Firmware 2.06.3 issue list:

List of bugs/improvement requests

List of workarounds – by bug number

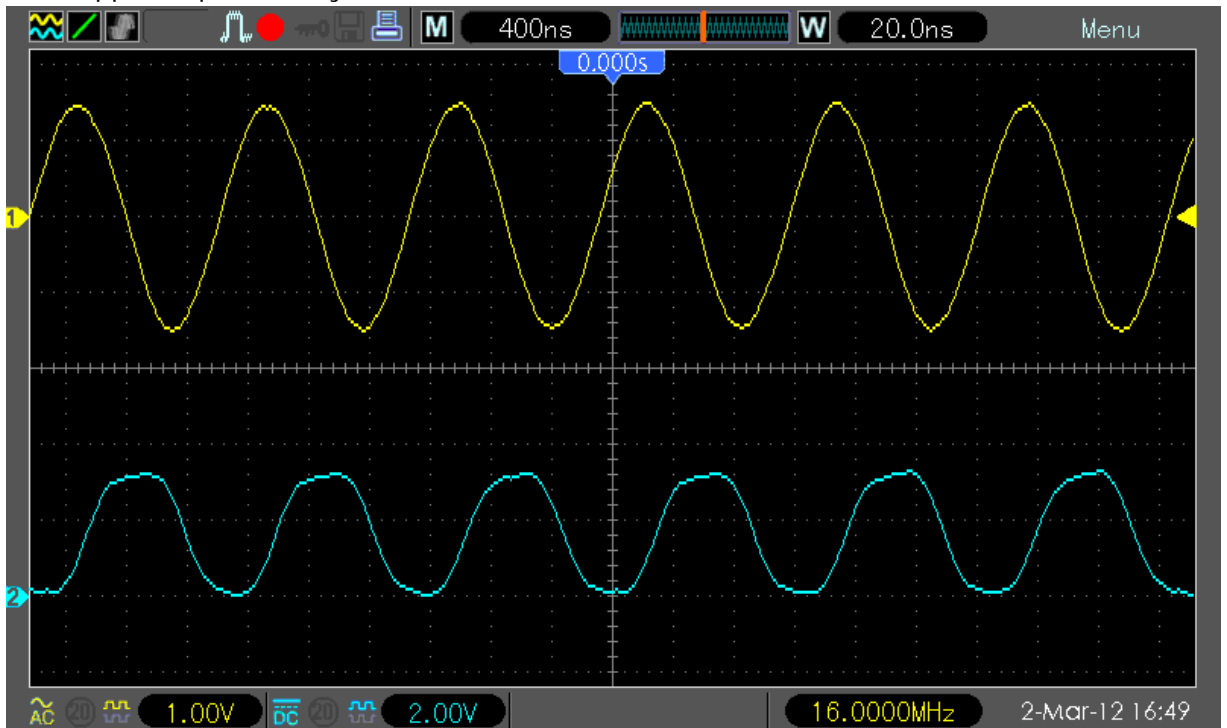
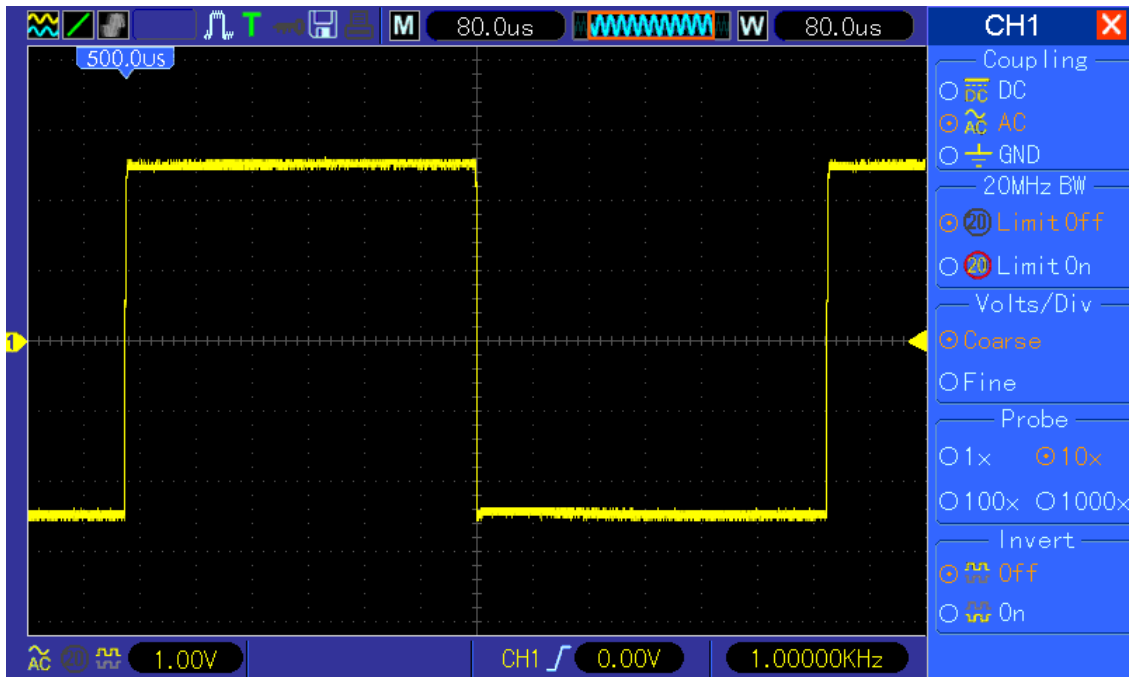
14. Dithering/interpolation filter of waveform too sharp. When enabling both channels (this also occurs in single channel mode and 1GSs, but test signal need to be higher to get same error) and applying for example 16MHz square wave the waveform is switching between proper square:

and crippled square every second:

14. For sure a stupid bug, but since you can see when the signal is “wobbling” you can quick change (when necessary) to single channel to observe the waveform with better resolution and without wobble.

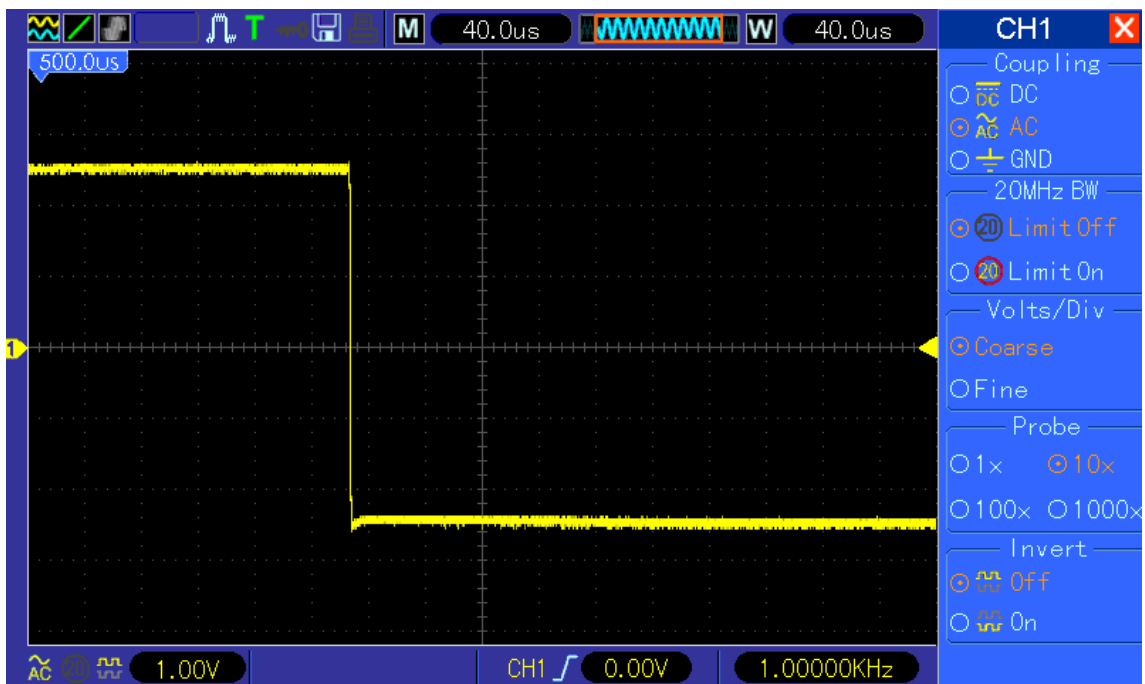
15. Display / Time base scaling strange behavior. When you apply e.g. 1kHz signal, set time base to 80us/DIV and move the waveform to 500us/DIV :

When you now change time base to 40uS/DIV the falling edge (which should be still in the middle of the screen) has been moved to 454uS position (but it should stay on 500uS). The same happens of course with 20uS/DIV.

15. Funny bug, but easy to omit since we know it.
16. This is already fixed, the /dsod (or /dso/app/dsod – this depends on fw/DSO model version) binary is working perfectly as watch dog monitoring potential profile issues.
